1990 - 1991 Corvette: Service Bulletin: 3-2 Coast Down Clunk

Subject: 3-2 COAST DOWN CLUNK (INSTALL SERVO SPRING)

Model and Year: 1990-91 CORVETTE WITH 4L60 AUTOMATIC TRANSMISSION

Bulletin Number: 91-372-7A - (06/27/1991)

Date of Production Change: (Figure 1)

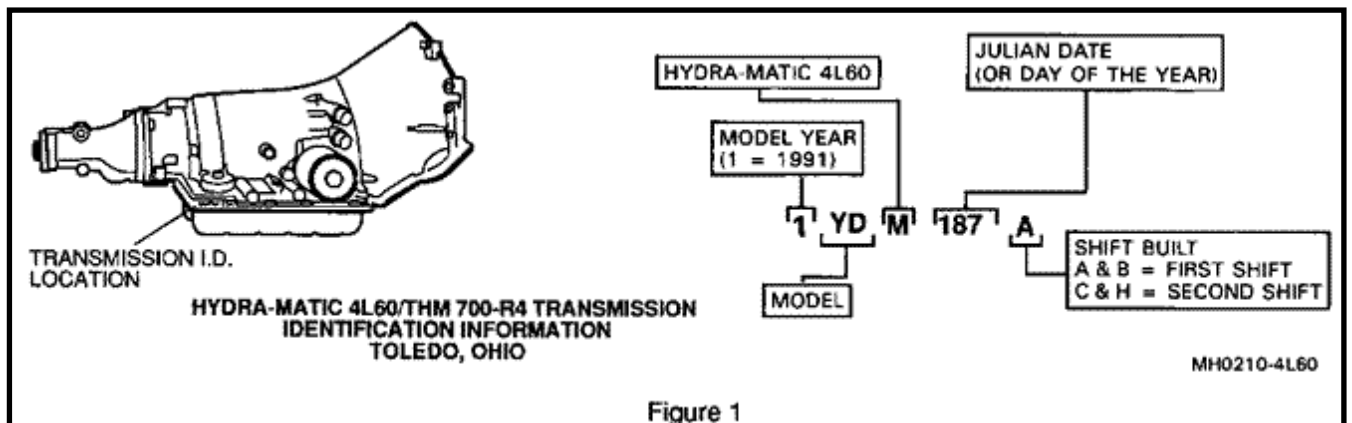
A new 2-4 servo cushion assist spring and spacer plate have been released to alleviate this condition. The new spring is a conical spring which nests inside the current 2-4 servo cushion spring. The new spacer plate has a modified third clutch exhaust orifice.

Beginning May 20, 1991 (Julian Date 140), all 1 YHM models of the HYDRAMATIC 4L60 were built using the new servo cushion assist spring and spacer plate.

Refer to Figure 2

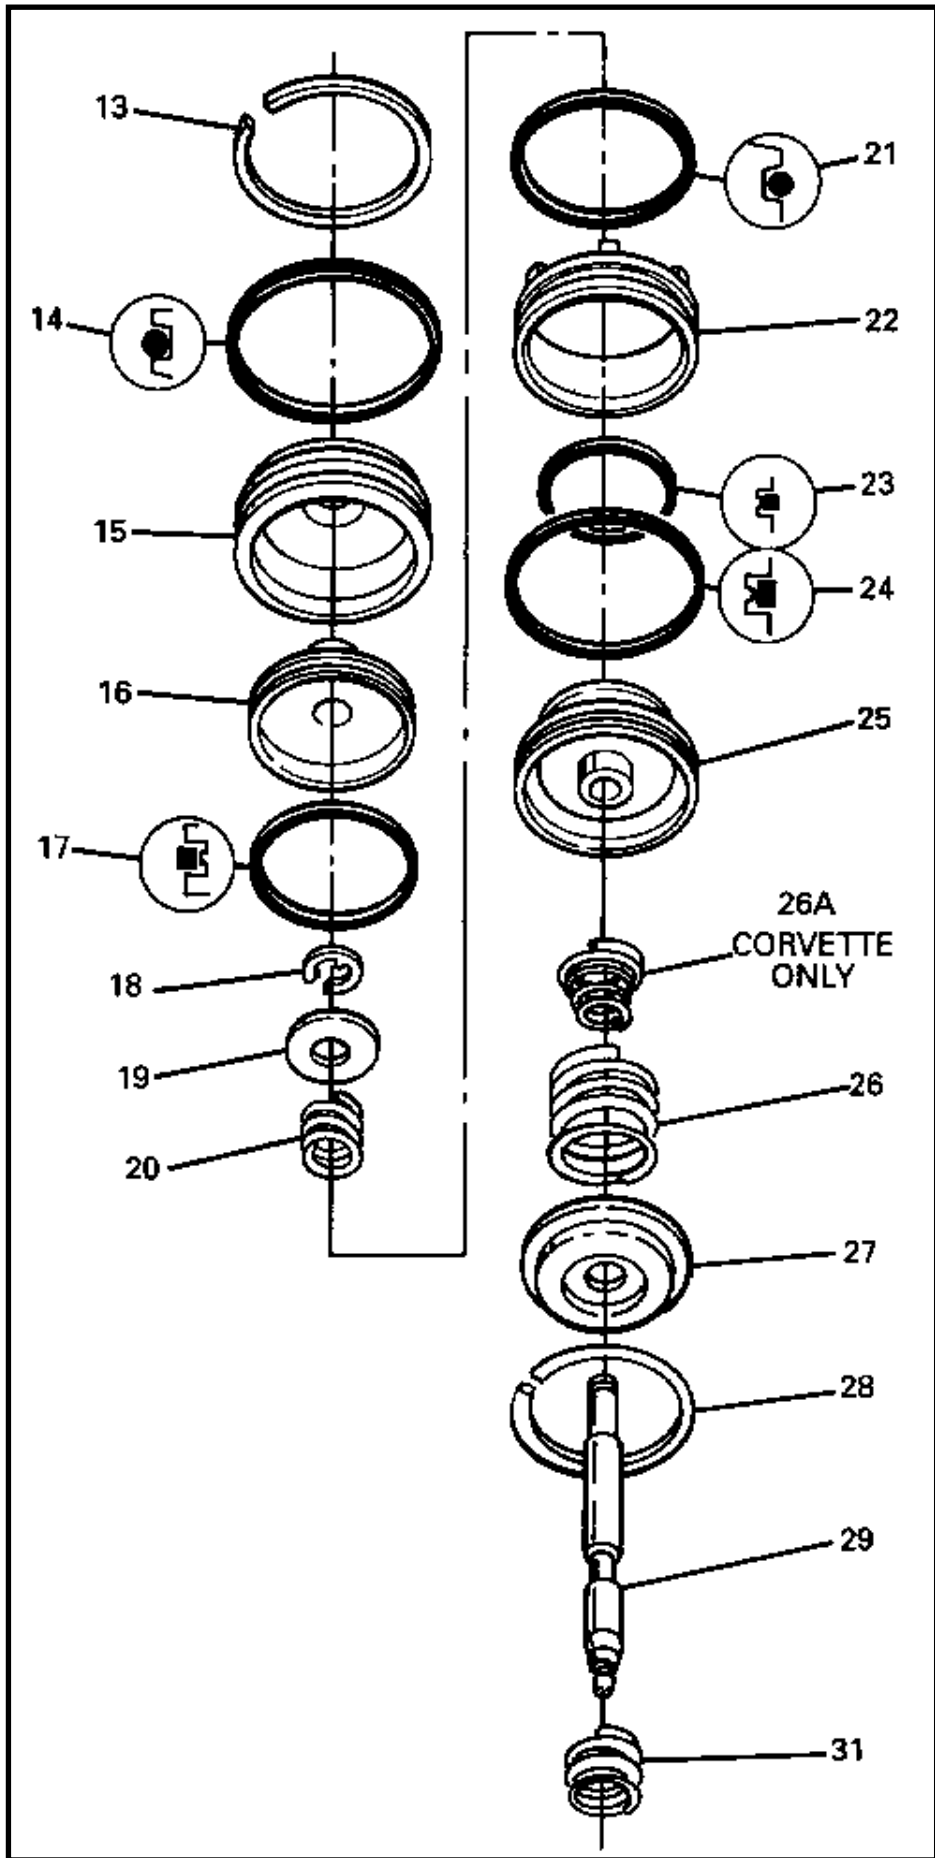
Install the new servo cushion assist spring inside the current servo cushion spring as shown in figure 2. Figure 2 shows the ONLY way the spring should be installed. Do not install the spring upside down. The new spring should not be used by itself.

Refer to the Automatic Transmission Unit Repair Section of the appropriate service manual for spacer plate removal and installation information. The 2-4 servo cushion assist spring is not shown in a service manual. Follow instructions for installing a 2-4 servo cushion spring, and add the servo cushion assist spring as shown in figure 2 of this bulletin.
